ADDENDUM #1

**IFB 25-121
STP-7302(698)
ASPHALT OVERLAY 2026**

This Addendum No. 1 modifies the original issued bid documents as follows:

IFB 25-121 Asphalt Overlay 2026 STP-7302(698)
 ADDENDUM #1 RRFB DETAIL

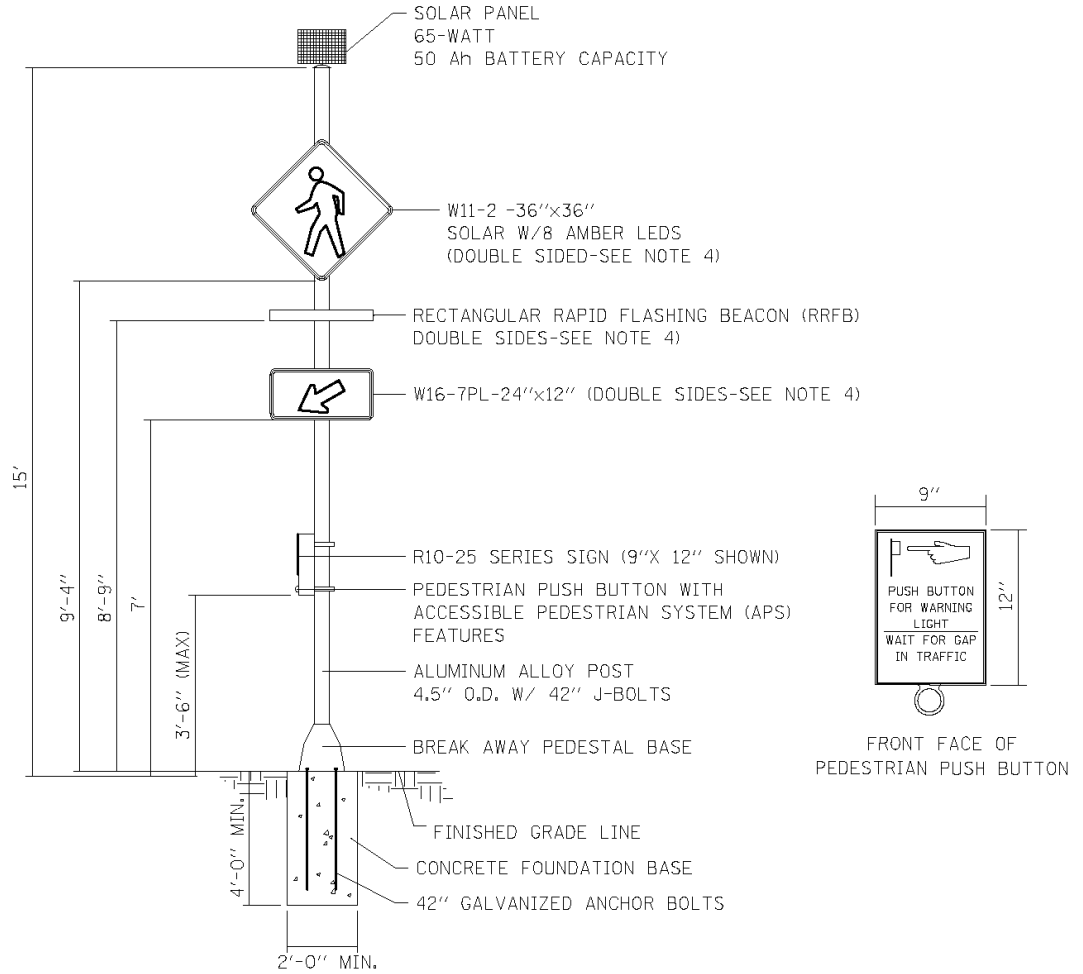
H. Add JSP J to the Job Special Provisions.

J. RECTANGULAR RAPID FLASHING BEACON ASSEMBLY

1.0 Description. This work shall consist of furnishing and installing a Rectangular Rapid Flashing Beacon (RRFB) assembly at the locations as shown in the plans. The installation shall comply with the latest version of the Manual of Uniform Traffic Control Devices, with the specifications detailed on the RRFB detail picture on the following page, and with all manufacturers’ recommendations.

2.0 Material. The RRFB assembly shall include all equipment and material necessary for the installation of one (1) solar powered unit. This equipment includes, but is not limited to, 15’ Signal Post, concrete base, signage, pedestrian pushbutton with APS, beacon, solar panel, control box, battery, wiring, mounting hardware and all additional equipment necessary for the installation of one solar powered unit which shall work in tandem with the adjacent RRFB across the street. All advanced signing associated with the crossing will be paid for separately from the contract plans.

Solar Panel. Solar panels shall be 65 watts with a minimum of a 50 amp hour battery.

Posts and Base. Standard pipe posts shall be round of outside dimension of 4.5”. Posts shall be made of Schedule 80 aluminum alloy 6061-T6 manufactured in accordance with ASTM B429 and threaded on one end. Posts shall thread into a square cast aluminum base made of aluminum alloy 319. The base shall be FHWA certified and meet AASHTO break away requirements and shall include an 8.5” square handhold cover. Base shall be mounted on a concrete foundation and attached by four internal galvanized anchor bolts of standard size 1”x42”. TAPCO or approved other manufacturer is acceptable.

Pushbutton. The installed pushbutton shall be compliant with the latest MUTCD, 11th edition in which the APS talking / vibrating pushbutton is required. Bulldog brand pushbuttons will not be accepted. The contractor shall include the manufacturer and model for the pushbutton as part of the shop drawing review. An acceptable product includes manufacturer Polara, Model XAV2E-LED or an approved equal.
